Work Order ID 98780

DART SERVICE INSTRUCTION

TO AMEND INSTALLATION INSTRUCTIONS IIN-D119-647 Rev. A AND
INSTRUCTIONS FOR CONTINUED AIRWORTHINESS ICA-D119-647 REV. 0

REF FAA STC: SR00949SE

Figure 1 - Bearpaw Location

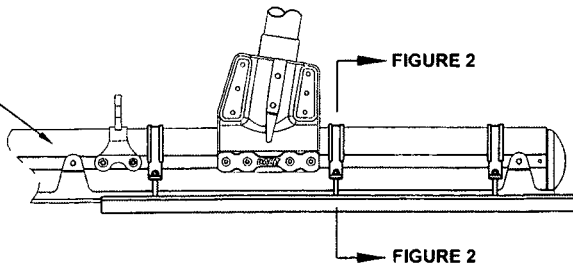
2.2 Position D3034-3 Bearpaw on the aft end of each skidtube so that the bearpaw clamps are located on either side of the aft saddle as shown in Figure 1 of this Service Instruction. The Bearpaws should be installed over the training wearplates.

Figure 2 - Bearpaw Installation

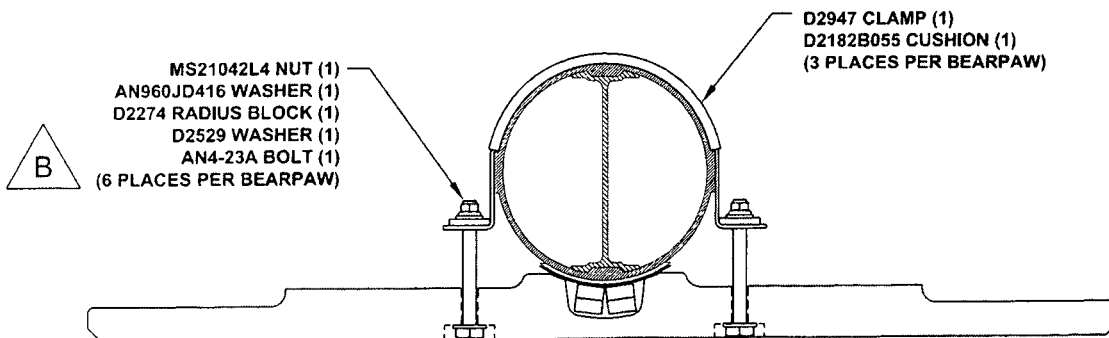
2.3 Attach the D2947 clamps with the hardware shown in Figure 2 of this Service Instruction. Additional AN960JD416 washers may be installed under the nuts to ensure 1.5-4 threads in safety on the bolts. Although not generally necessary, it is also acceptable to replace the AN4-23A bolts with longer or shorter AN4 bolts, if required.

CAUTION: The torque on the nuts should be limited to 20 in-lb (2.3 Nm)
